Notice of Alteration – R.M. of Ritchot Waste Disposal Ground,
Environment Act Licence No. 2482R

FINAL CLOSURE - CELLS 1 TO 5
CLASS 1 WDG
 1373 BERNAT ROAD
 RM OF RICHOT, MANITOBA

**Slope Stability Analysis
Proposed Cell Height Increase
MidCanada Environmental
Ile Des Chenes , Manitoba**

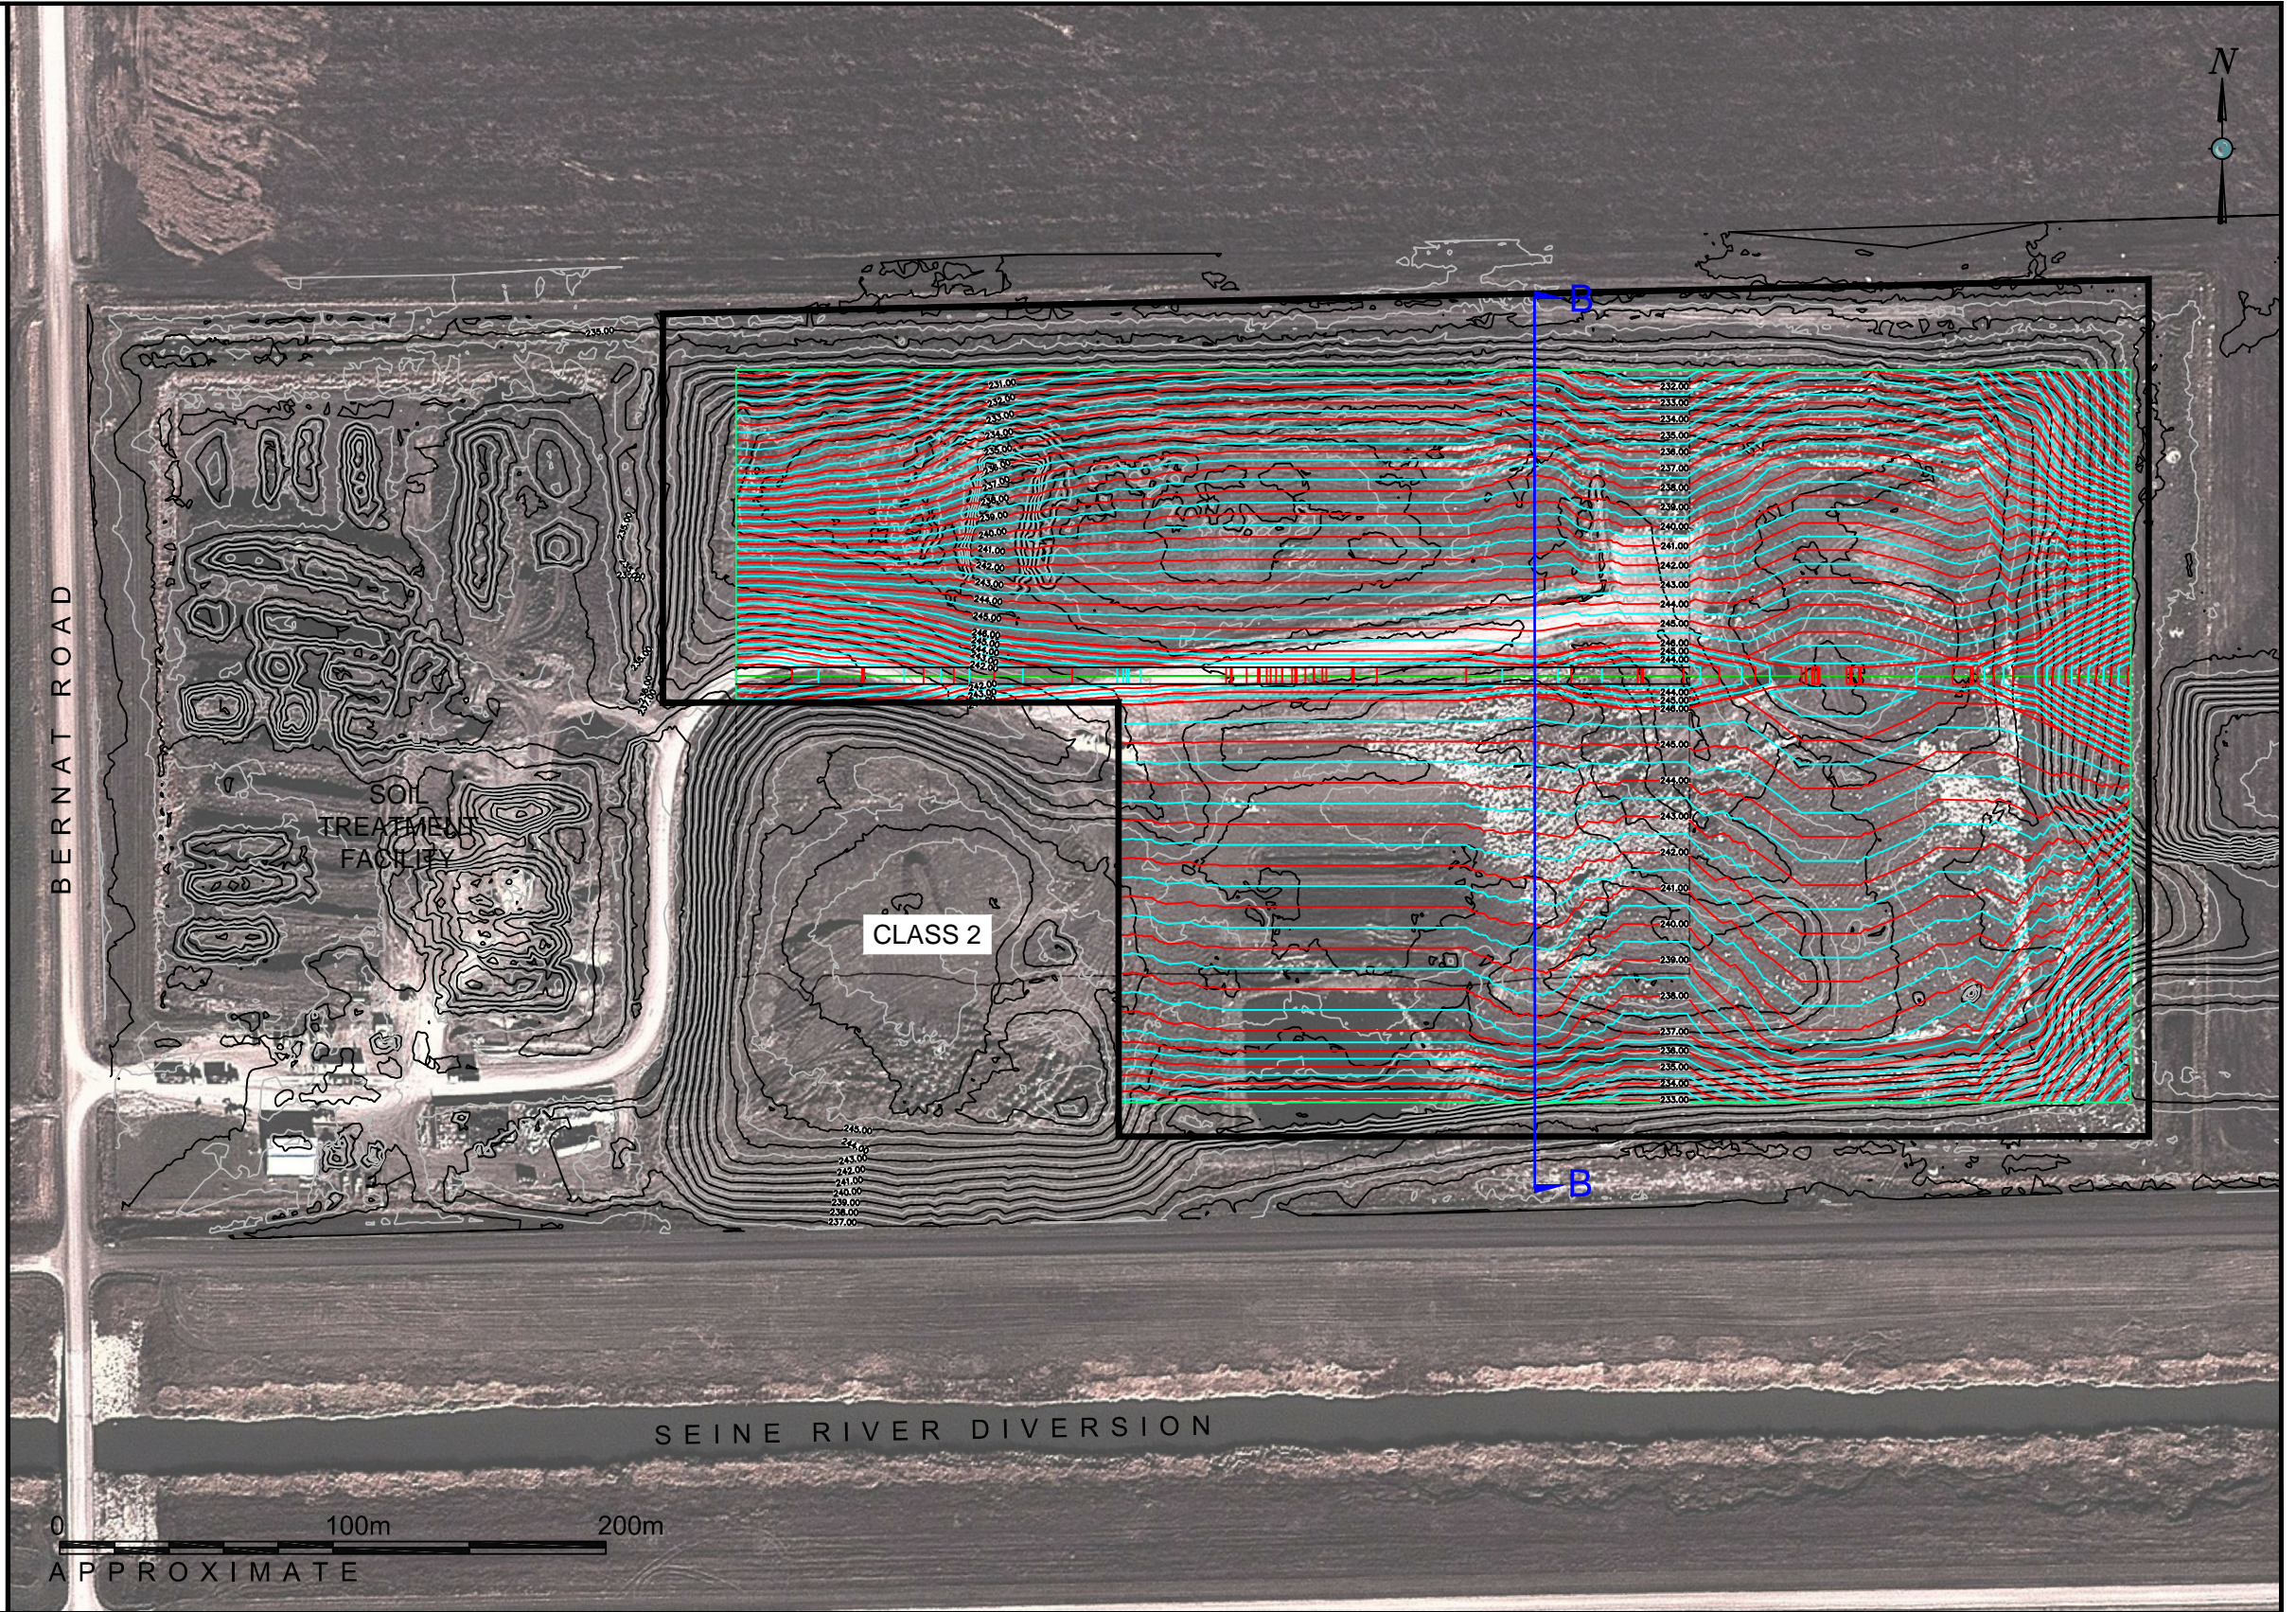
Once the soil stockpile contours have been completed, the final clay cap will be installed as shown in Figure 2. The final cap will consist of a minimum depth of 0.5 m. of clean high plastic clay compacted in maximum 200 mm thick lifts to a density of 95% SPMDD using a heavy sheepsfoot compactor. When compaction tests confirm that the required density has been achieved, a 150 mm layer of topsoil will be applied over the subject area. The area will be seeded with a mix of drought-resistant native grasses.

Increasing the height of the cells without appropriate mitigation could result in increased erosion of the side slopes resulting from the higher flow speed of run-off water from the top of the area. This could, in turn, result in increased suspended solids in the run-off. It is proposed that this risk be mitigated by incorporating a bench along the side slopes at the top of the original cell berms to slow the flow of water and by adding vegetation to the side slopes to stabilize the underlying soil layer. The configuration is shown on the cross section view in Figure 2.

FIGURE 1

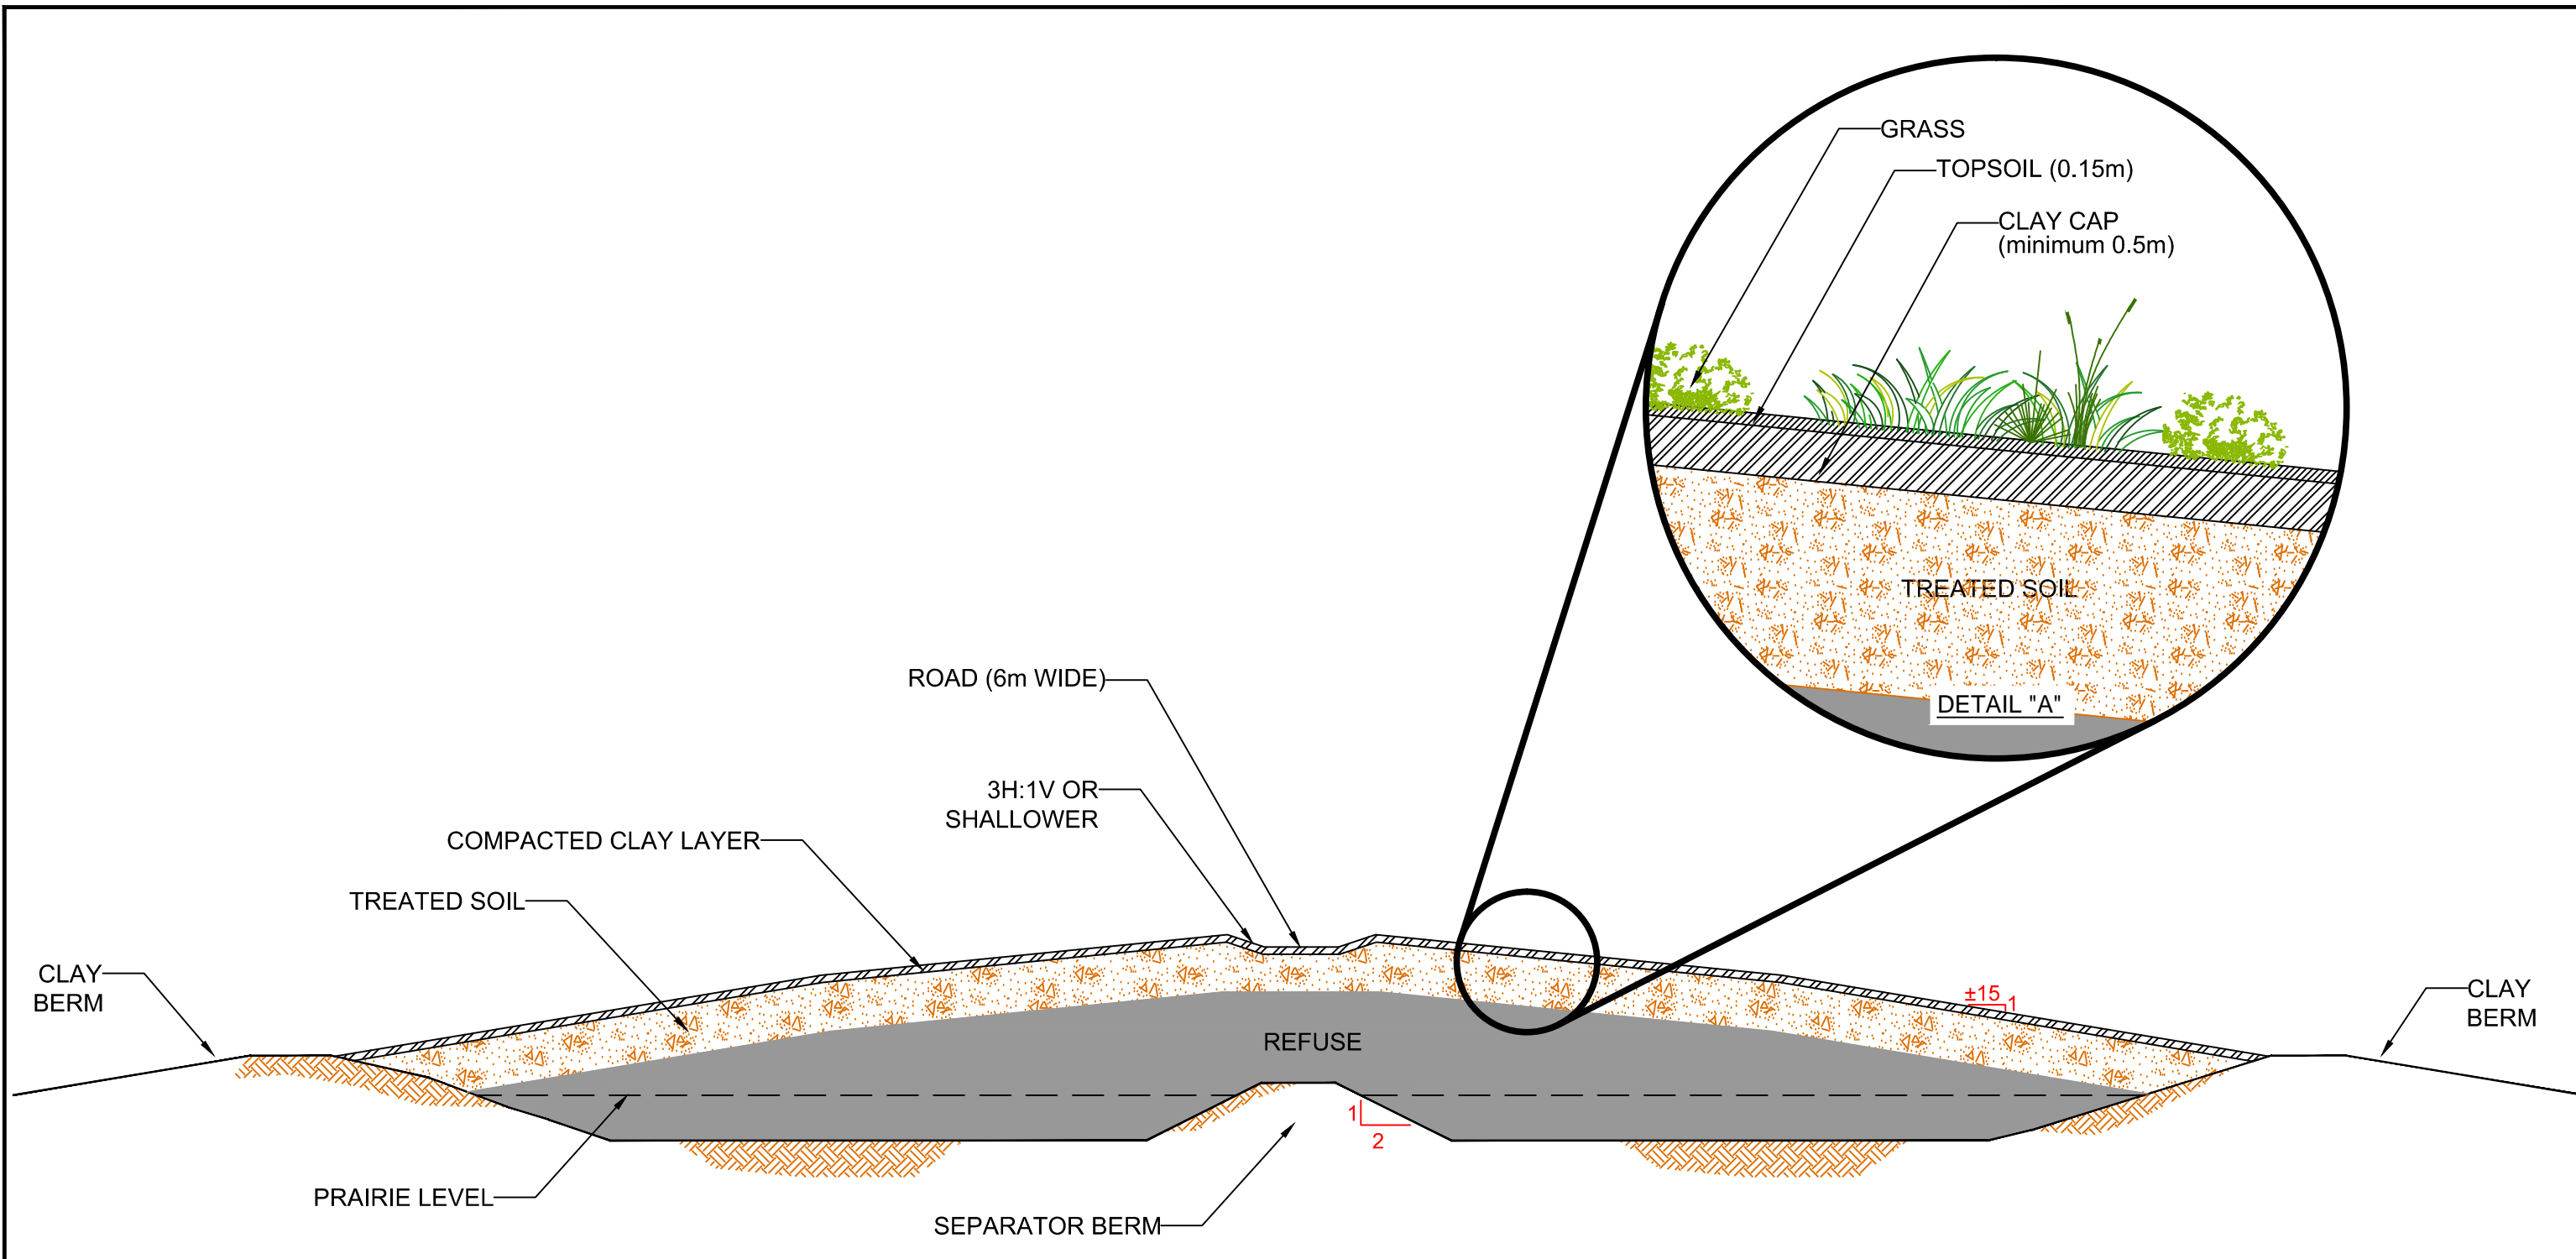
It is being proposed to increase the landfill cell finished heights from the current 8 metres to 12 metres above prairie grade. This would apply to all cells that have been closed to date. This includes Cells 1 to 5 as shown on Figure 1.

The existing soil stockpile will be graded to conform to the elevation contours shown in Figure 1. Sufficient space will be left to add the final cap without exceeding the proposed 12 metre elevation. The surface contours will direct drainage to the north and south perimeters of the subject area. A small percentage of surface run-off will be picked up by the drainage ditch along the main access road going through the approximate centre of the area. On the south side of the subject area run-off will enter a municipal drainage ditch on the north side of the road adjacent to the Seine River Diversion. The majority of run-off entering the ditch will flow east and enter the Diversion via a culvert under the road. Due to the design of the ditch, a smaller volume of run-off will flow west and enter the Diversion near the south-west corner of the closed Class 2 waste disposal ground.
